Comments on the January 2011 Revised Draft
Specification for Weather-Based Irrigation Controllers

May 19, 2011

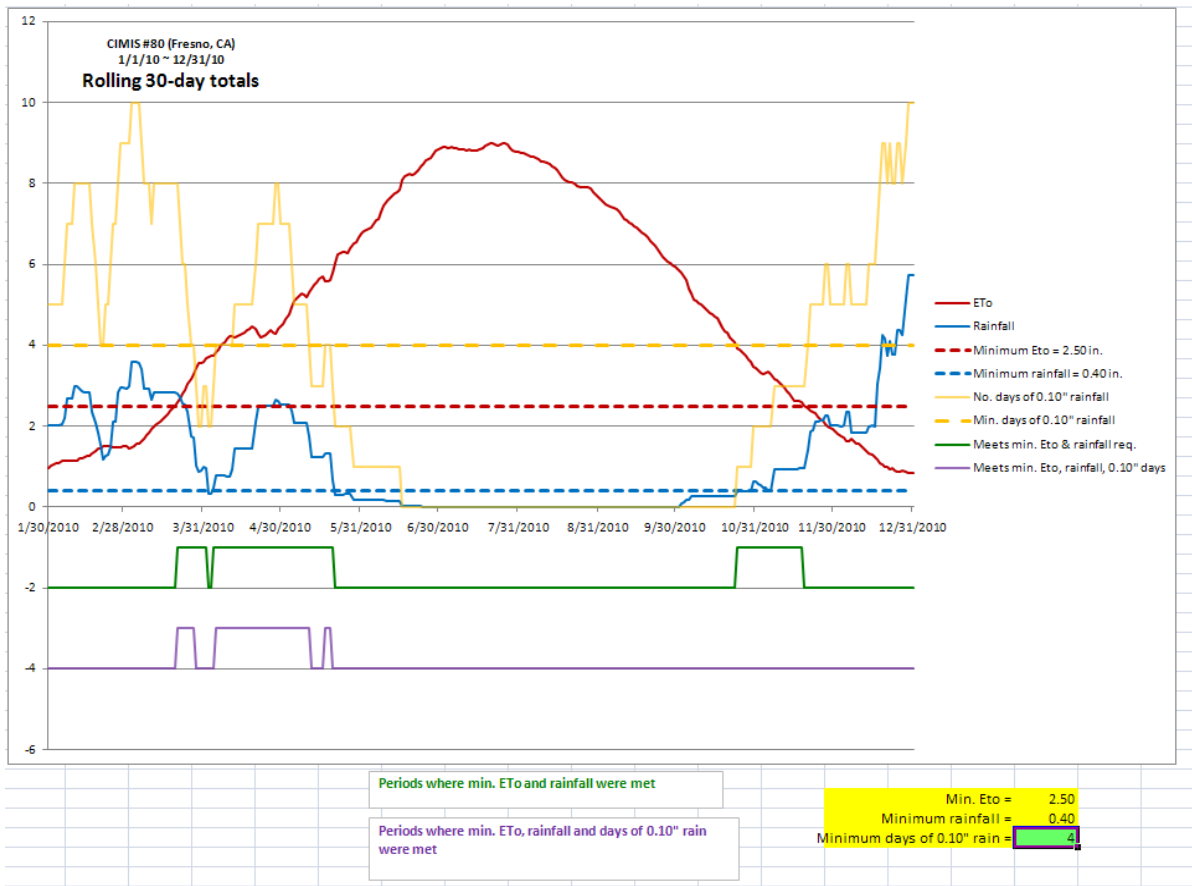
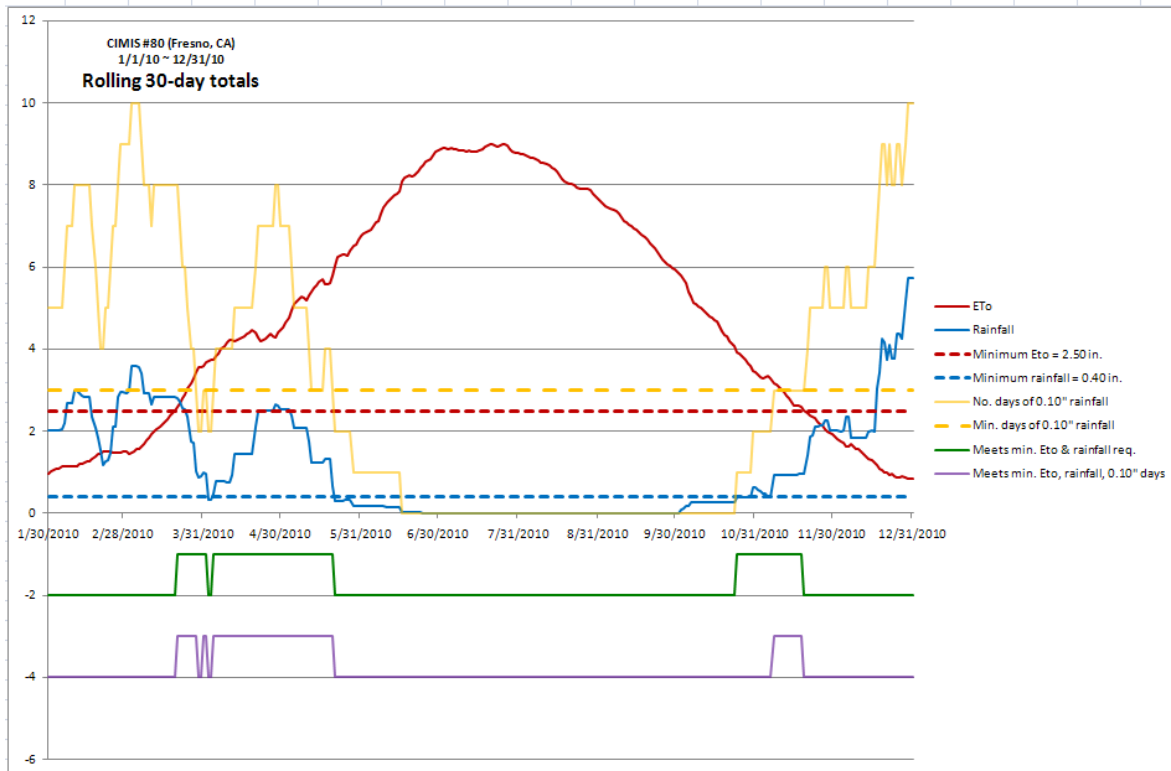
Comment: If the test is done in California (or other dry areas with little rainfall), this may be difficult to achieve.

Rationale: It's hard enough to meet the criteria with the current SWAT protocol. There's only about 2 periods out of the year where you can meet both the minimum requirements of ETo = 2.50 in. and rain = 0.40 in.. After crunching 2010 data from CIMIS Sta. #80, I found the additional 4-day requirement reduces the qualification period to only one period in the year (mid-Feb to mid-Apr) (see attached chart). If you reduce the requirement to 3 days, it opens up

another small opportunity in the fall. Another option is to extend test period to 60 days, and doubling the ETo and rainfall requirements to 5.00 inches and 0.80 inches, respectively.

Suggested Change (or Language): Keep the current 30-day requirements but reduce the requirement of 0.10 inch rain days from four to three.

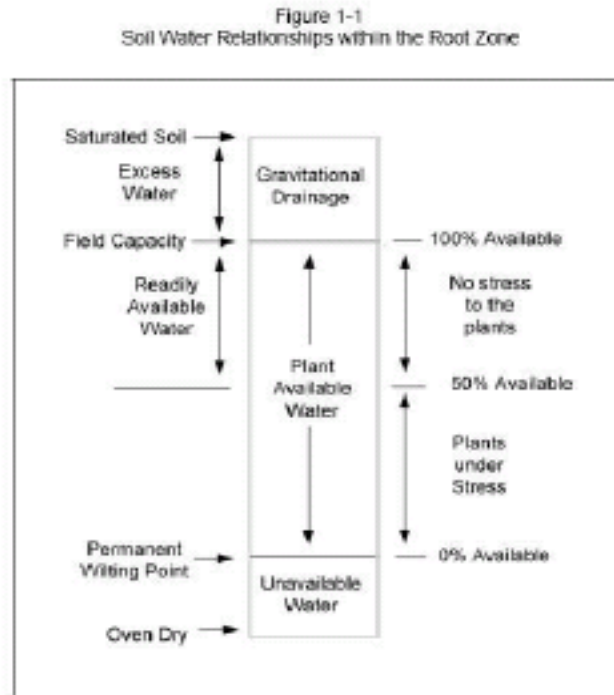
Comment: The report from the University of Florida had numerous references to affect of rain on test results. This new revised specification addressed some of the issues by changing the “Order of Operations” and the requirement for at least 4 rain events. But there is room for additional refinement in the test protocol. The soil moisture model that defines performance standard should more accurately reflect real-time conditions.

“RN = 0.8 (R), in. - Allows for an arbitrary loss of 20% of the rainfall to non-uniformity and runoff.”

The key word in this statement is “arbitrary”. Why should the EPA use an arbitrary value in this test when better science is available?

Suggested Change (or Language):

1) Change the Moisture Balance Spread Sheet calculations to an hourly time step. This means rainfall, ET and irrigation would be accounted for on an hourly basis. The model is far more accurate.
